Draft Determination

National Gas
Transmission
document response

**Our response to Ofgem's
assessment of our RIIO-GT3
(2026-2031) business plan**

Chart 1

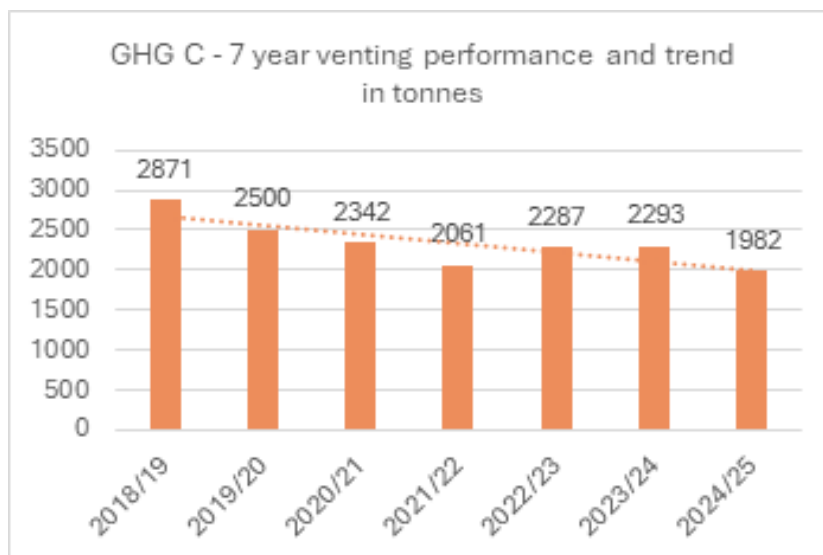
23. Based on the difference between our Business Plan and Ofgem's Draft Determination we propose using a 7-year average between 2018/19 to 2024/25, (including the most recent performance year) to set the target allowance

at 2,334 tonnes. Using this longer-term range allows the coldest and most recent winters and reduction in compressor hours in RIIO-T2 to be considered, whilst recognising the challenges described above. We believe the proposed approach strikes a reasonable balance. It continues to incentivise us to find innovative solutions to reduce emissions, while still enabling us to meet our obligations and provide customers with the flexibility to meet their needs.

Chart 2

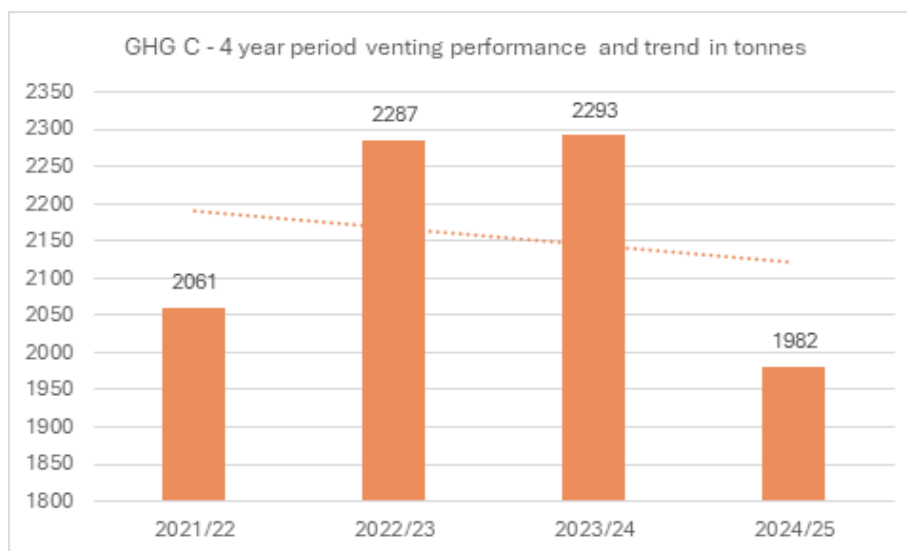
26. Including 2024/25 data, which was unavailable when we submitted our RIIO-GT3 Business Plan, suggests that a more appropriate improvement factor would be approximately a 20-tonne annual reduction. Chart 2 on the next page illustrates the variability if we used 2021/22 to 2023/24 data, and shows a 77 tonne a year increase in the target. We recognise that this timeline doesn't align with the example to set the target based on 7 years, but the target has already accounted for a large proportion of this improved performance. As such, we believe that a 20 tonne per annum improvement factor is appropriate.

Chart 1

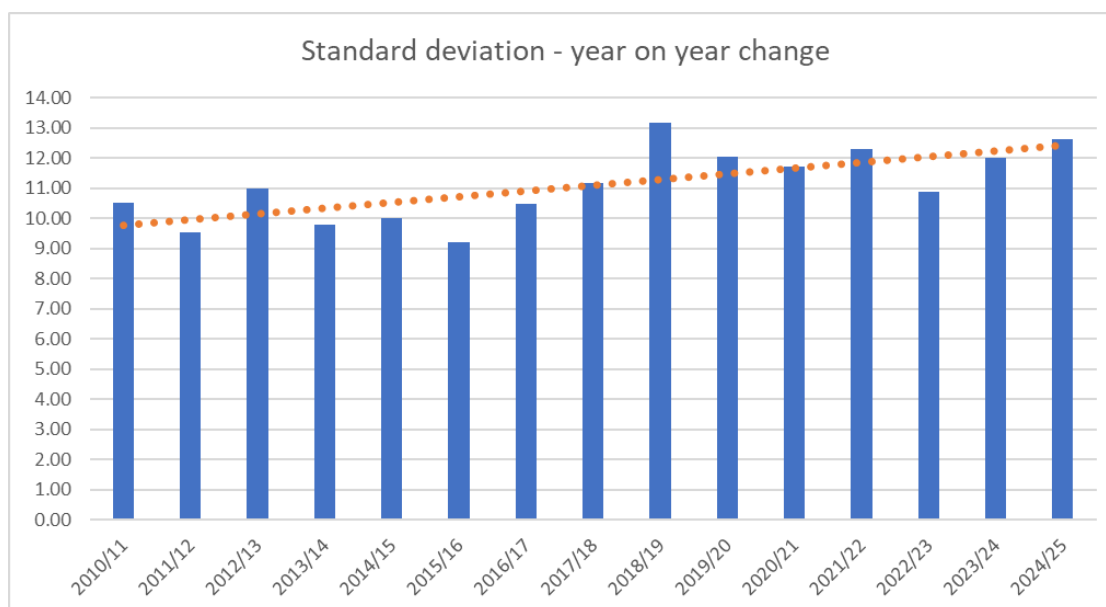
173. The chart below shows a clear upward trend in volatility, 2024/25 was the second most volatile year in terms of day-to-day demand changes over the past 15 years.

Chart 2

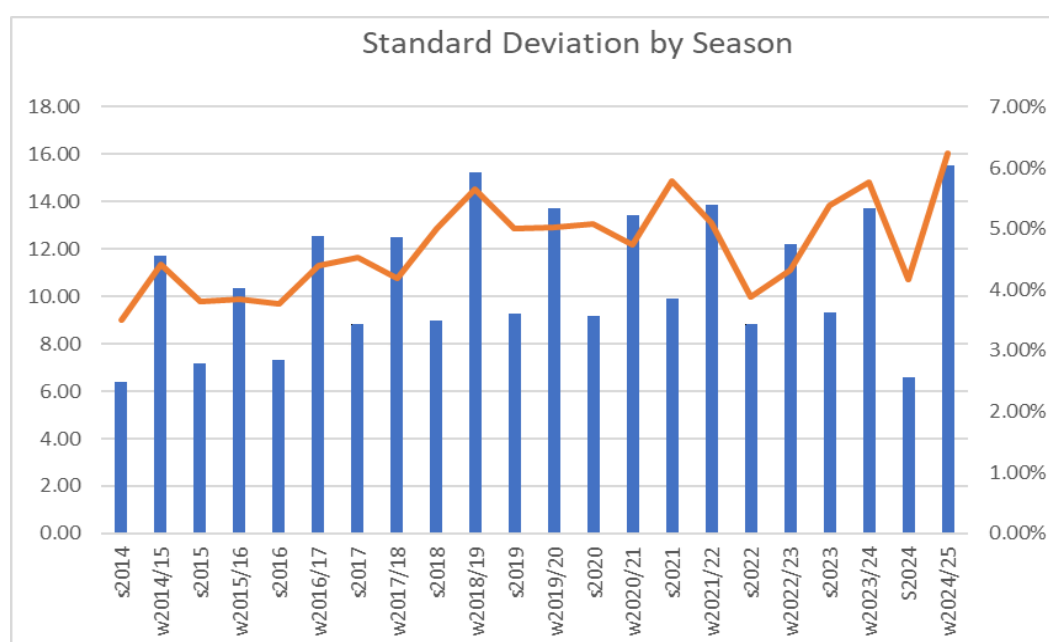
174. The next chart shows a seasonal perspective, where 2024/25 demonstrates a contrast between seasons which equates to a 2 ½ times seasonal difference, as outlined below:

- The summer demand standard deviation was the second lowest on record at just 6.61 mcm/day.
- Winter demand standard deviation was the highest ever recorded at 15.51 mcm/day, more than 2 mcm/day above the rolling five-year average and when converting that to a % of average daily demand it represents ~6%, the highest proportion ever observed.

Chart 11

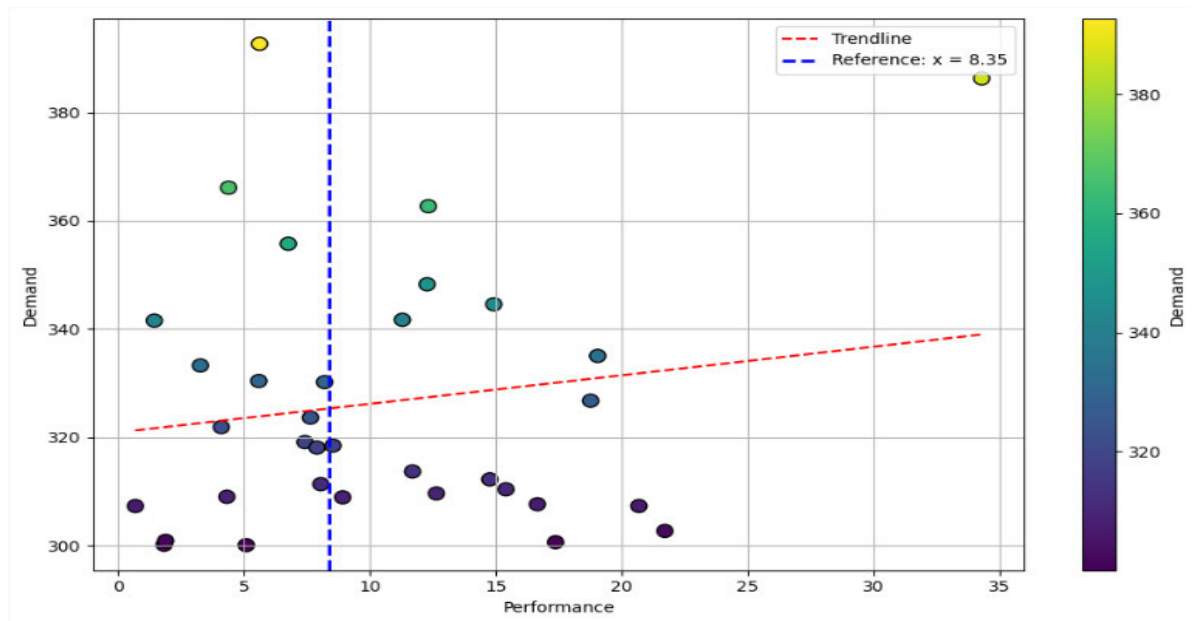
200. The RIIO-T2 weighting mechanism within the incentive structure creates a reverse asymmetric risk-reward dynamic. Larger forecast errors are more likely during winter due to heightened weather uncertainty and can result in significant financial penalties, while accurate forecasts yield only modest rewards. As a result, risk aversion is created, aiming for the 'midpoint' when forecasting amid uncertainty and volatility.
201. Chart 11 shows the UK gas demand over 300mcm for the financial year 2024, alongside corresponding forecasting performance. A linear regression line shows a clear upward slope, indicating that as demand increases, so does the difficulty in forecasting accurately. Out of the 34 high demand days analysed, 17 (50%) were classified as 'poor performance days', where D-1 forecast errors exceeded 8.35mcm.

Chart 21

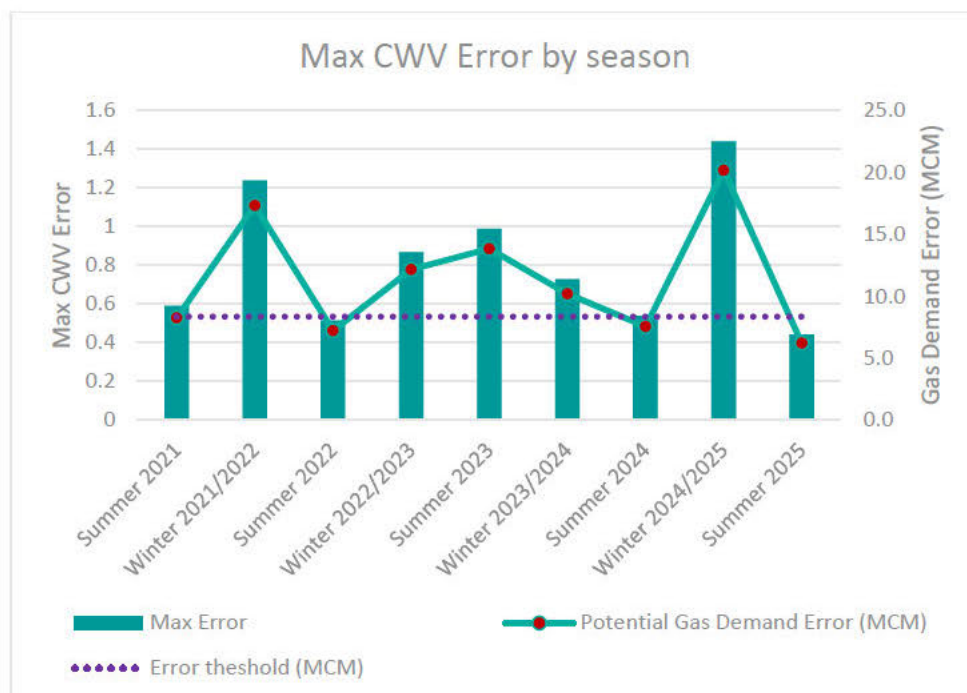
220. In trying to further understand our gas demand forecast, we conducted analysis on day-ahead CWV forecasting errors and their potential impact on demand forecast accuracy.

221. The results show that gas demand forecasts are highly sensitive to CWV accuracy, as shown by the strong alignment between CWV errors and potential demand errors across seasons. When CWV less accurate, especially in the winter, demand errors could exceed 20mcm, far above the current threshold at 8.35mcm. This demonstrates that even small inaccuracy in CWV can lead to significant impacts on demand forecast.
222. Since CWV is an external input, applying seasonal weighting amplifies the impact of these errors. This results in a skewed assessment of forecast performance, disproportionately penalising winter periods. Given this, we recommend removing the weighting and revisiting the target to better reflect the structural limitations of the input data and ensure a more balanced and realistic evaluation framework.
